DEVELOPMENT REVIEW BOARD
SUPPLEMENTAL SUBMITTAL

PROJECT NO. 2022-006547

Application No. SI-2022-00216

RE: Panda Express – S8-22-D8582
10126 Coors Blvd. NW
Albuquerque, NM 87114
RE: DRB Planning Review – 1st Resubmittal
DRB Project Number: 2022-006547
App. Number: SI-2022-00216

4 DIRECTIONAL ARROWS NTS

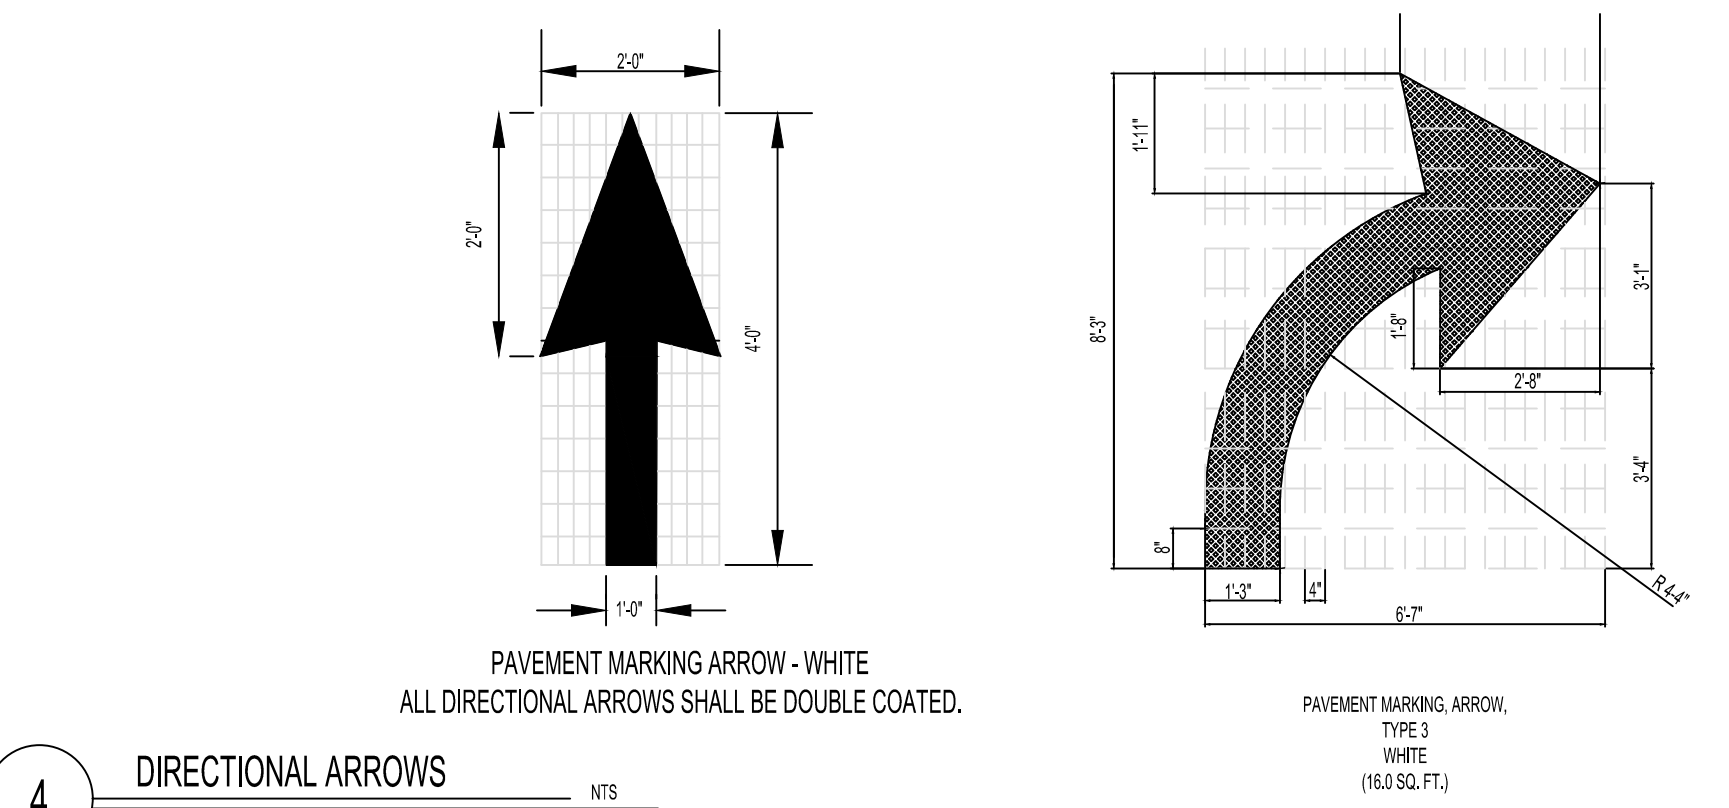
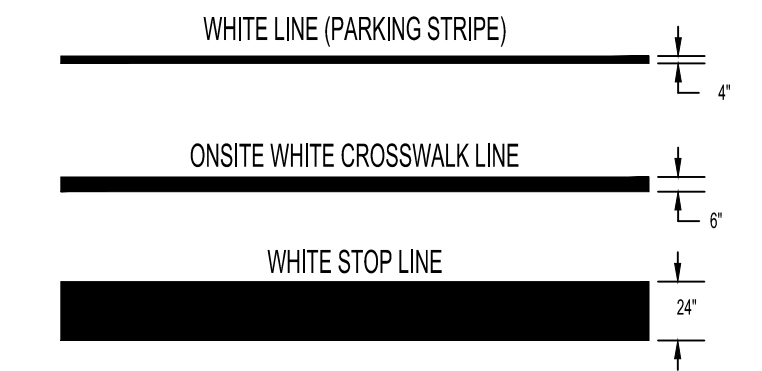
9. Call out curb on the site plan with keyed notes. A minimum 6"-8" curb is required to separate parking lot and spaces from landscaped islands and sidewalk.

10. Provide handicapped signage details, and show "No Parking" on the pavement in the back of the van accessible aisle. Label handicapped spaces with a keyed note on the site plan.

Response: Refer to detail sheets C03.2, C03.3 and C03.4 for further information.

Response: Refer to sheet C03.2 Hardscape Details I

A-100
 SITE PLAN
 ARCHITECTURAL

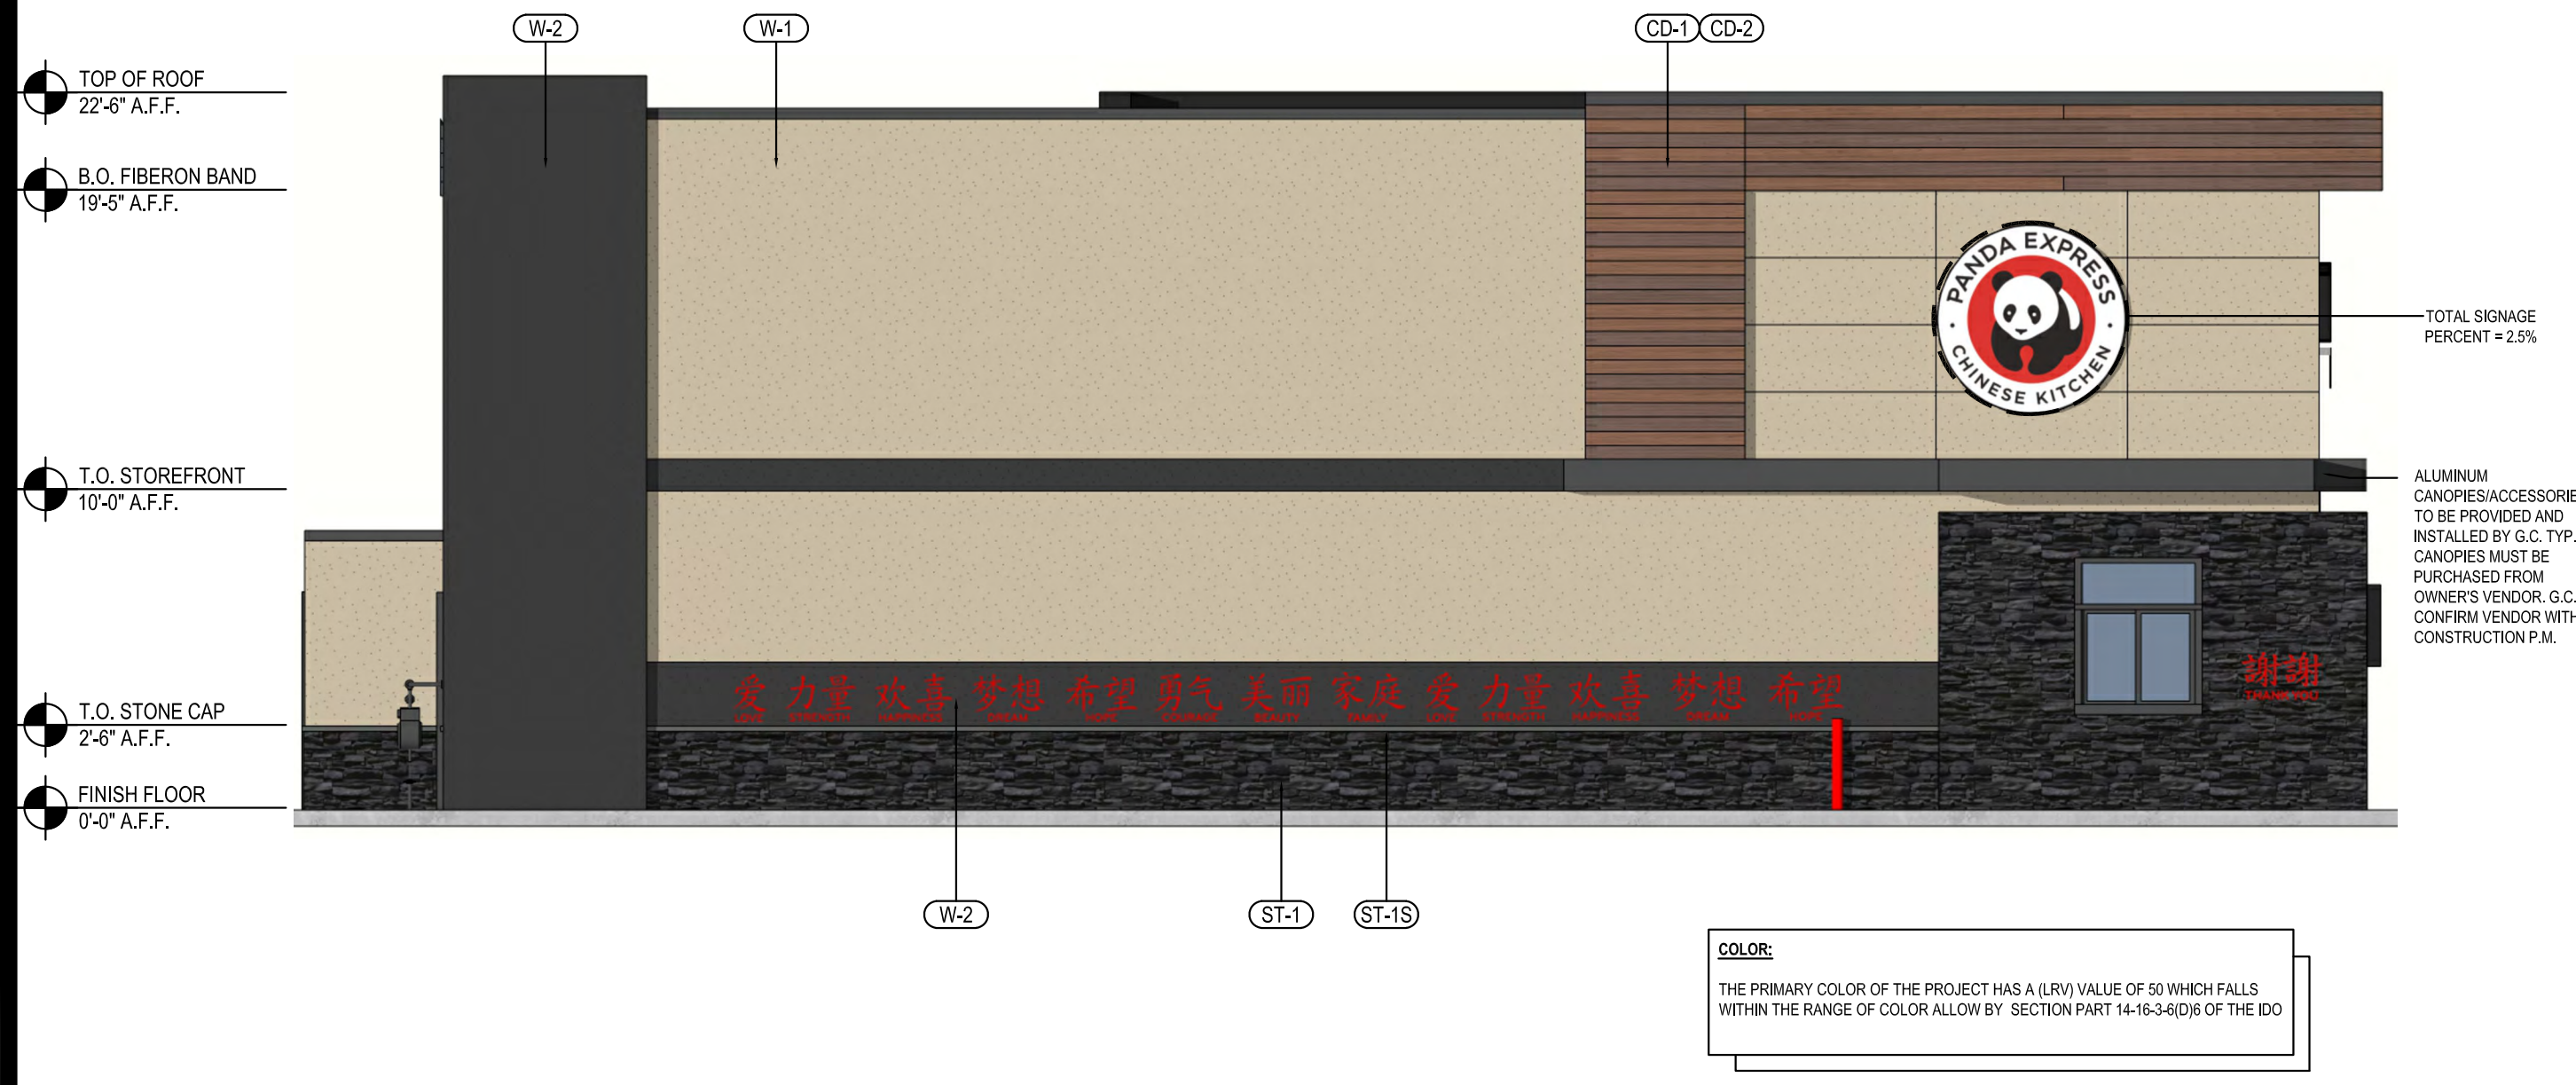
2. Dimensional standards and setbacks must meet all requirements of the MX-L, CPO-2, and VPO-1 sections of IDO. Please note CPO-2 requires a 35 foot setback from Coors Blvd, and indicate all setbacks to the building on the Site Plan.

3. As per VPO-1, IDO 3-6(D), sight line/ view frame analysis & elevations will be needed if there is building on the Site Plan.

8. Show stacking with 20-foot minimum car lengths. A minimum of 12 vehicles for a restaurant is required per IDO. Also, provide a queuing analysis for this specific restaurant to determine additional stacking requirements.

14. Provide clear intersection sight distance triangles at the entrance. Reflect these on the site plan and landscaping plan. Provide standard note on landscaping height requirements within this sight triangle.

Response: All setbacks/ distances from the property line can be found on the sheet C03.1 Stacking Plan and sheet A-100 Site Plan.

Response: Refer to sheet A-100 Site Plan for sight line/ view frame analysis.

Response: Sheet A-100 Site Plan, drawing has been updated and now shows 12 vehicles per IDO requirements. Refer to Parking Calculation and refer to typical car legend. Per Panda national standard please see chart below for typical queuing information.

Response: Refer to sheet A-100 Site Plan and L-1 for sight distance triangles at entrance.
